RE: BREMERTON AUTO WRECKING LANDFILL GROUNDWATER MAP

The Kitsap County Health District (Health District) is writing to comment and clarify the groundwater situation you discussed in your letter to the Health District dated February 14, 2003, regarding the Bremerton Auto Wrecking Landfill (BAWL).

Subject: Gorst Creek Hydrologic Modeling

**RE: Review of conditions and interim action alternatives for Gorst Creek
Landfill, Kitsap County, Washington, Delivery Order 50, Task 38.**

Bremerton Auto Wrecking Landfill

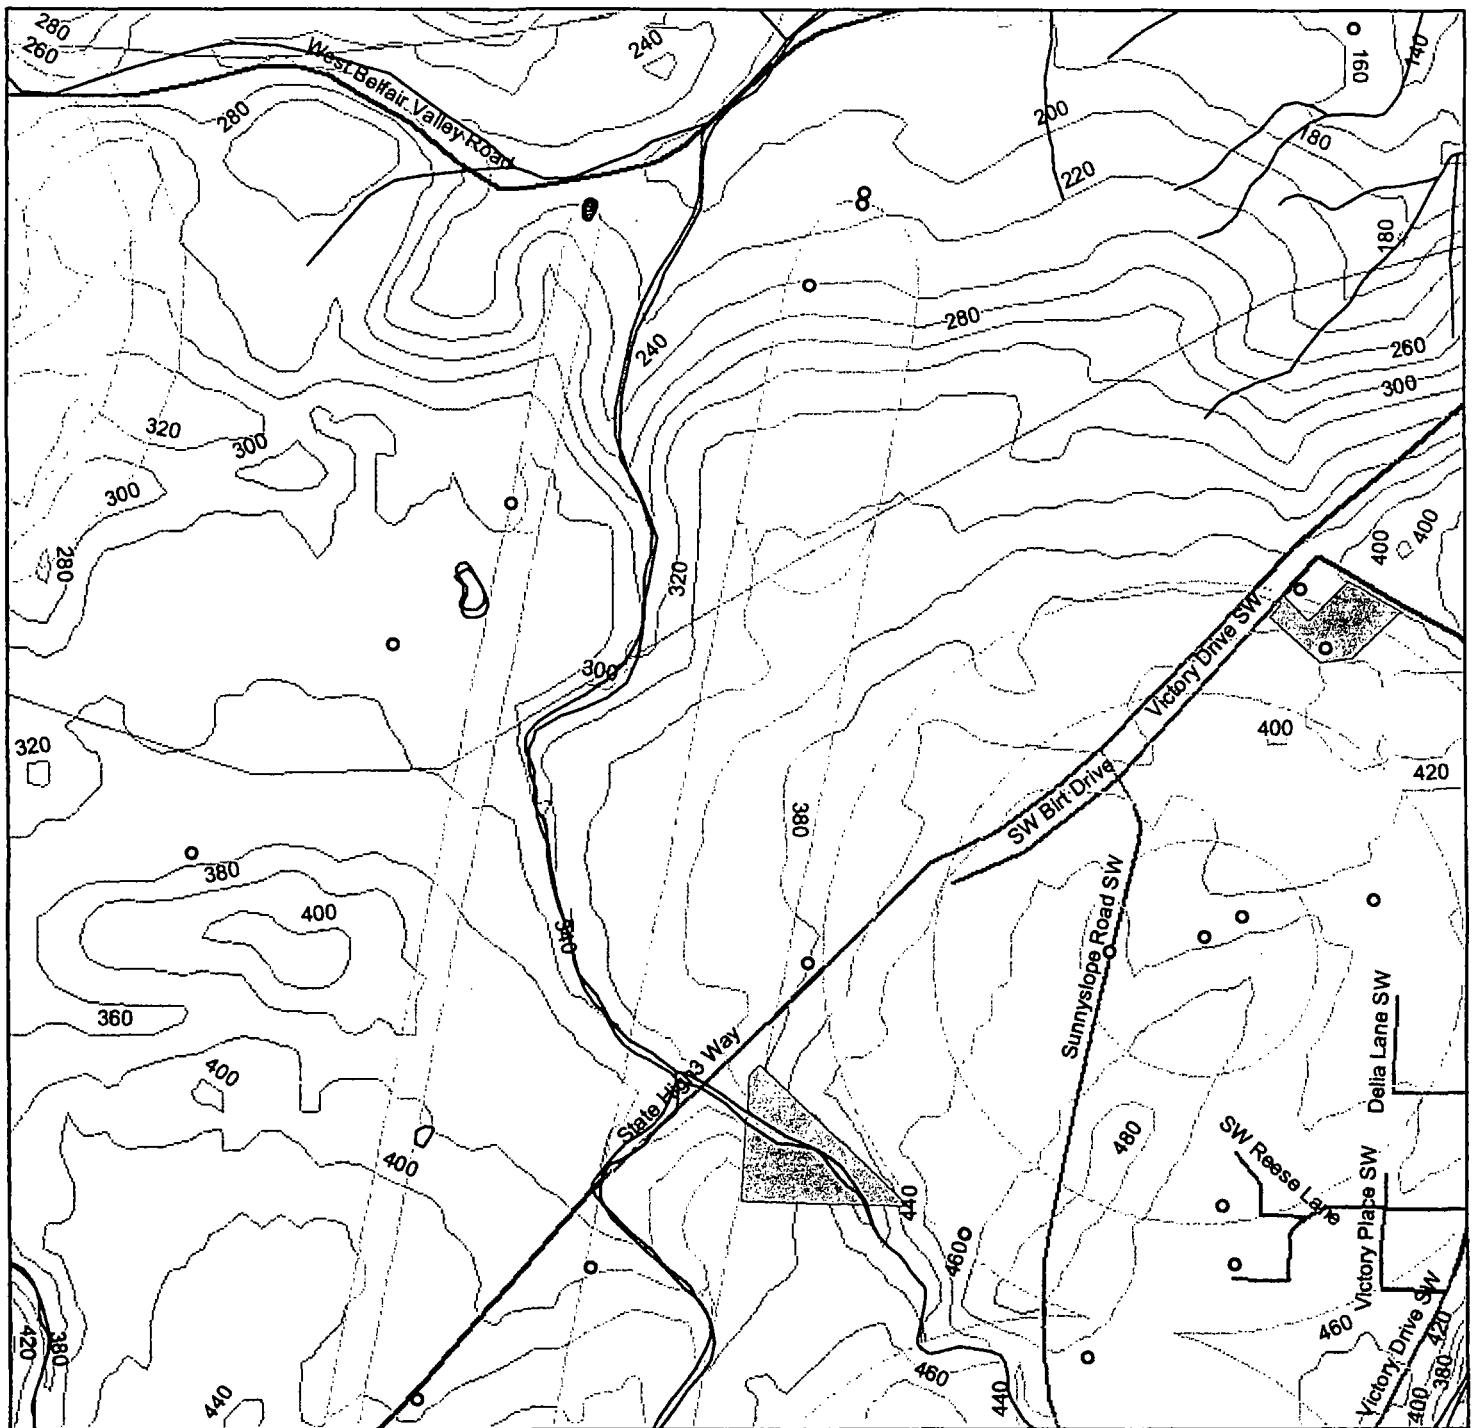
Attached is a map developed in our office with data from the local water PUD and Kitsap County's GIS office. The orange triangle shape in the lower center of the map is BAWL. The travel bars that run diagonally from bottom to top have at their head the City of Bremerton production wells for approximately 10,000 persons. Given the topography and the heavy drawn down from the City of Bremerton production wells it is reasonable to assume that groundwater flow is to the north, not northeast as stated in the SHA.
